SERVICE BULLETIN

MITSUBISHI MOTORS

PURPOSE : INFORMATION	ISSUE NO. : MSB-12EXML42-002A	DATE : 2013-1-21
SUBJECT : ADJUSTMENT OF DOOR STRIKER FOR THE VEHICLES WITH SIDE AIRBAGS(built-in by a seat) AND CURTAIN AIRBAGS		<Destination/Model> (ALL DESTINATIONS) <M/Y> ALL
GROUP : BODY		ALL MODELS WITH SIDE AIRBAGS(BUILT-IN BY A SEAT) AND CURTAIN AIRBAGS

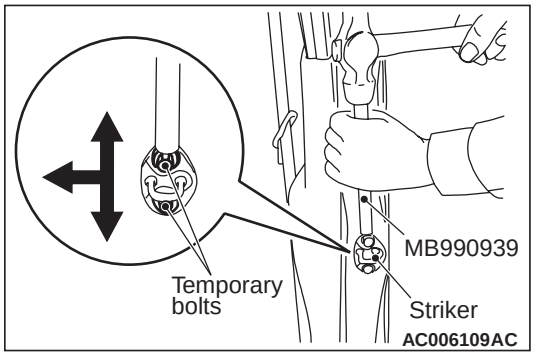
To avoid inadvertent airbag deployment, always turn ignition switch to the "OFF" position and wait 60 seconds or more before adjust the striker.

~~**To adjust the striker, always turn the ignition switch to "LOCK" (OFF).**~~

(1) Adjustment using the striker (toward the inside of the vehicle and vertical direction):

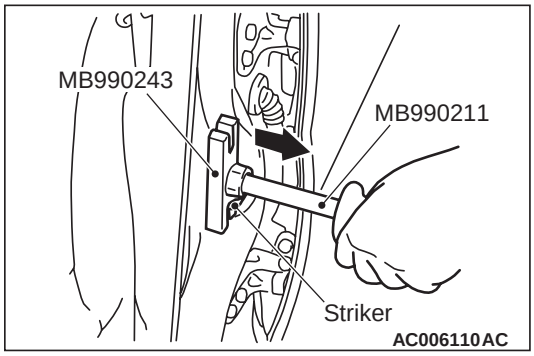
Install a temporary bolt instead of the striker mounting bolt, and use the remover bar (Special tool: MB990939) and a hammer to tap the temporary bolt to the desired direction.

(2) Adjustment by using the striker (toward the outside of the vehicle):

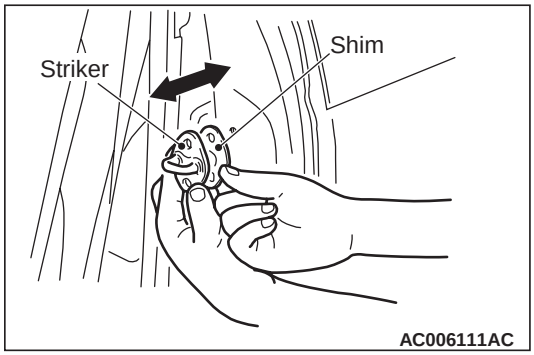
Using the following tools, pull the striker toward the outside of the vehicle to adjust.

- Slide hammer (MB990211)
- Body puller (MB990243)
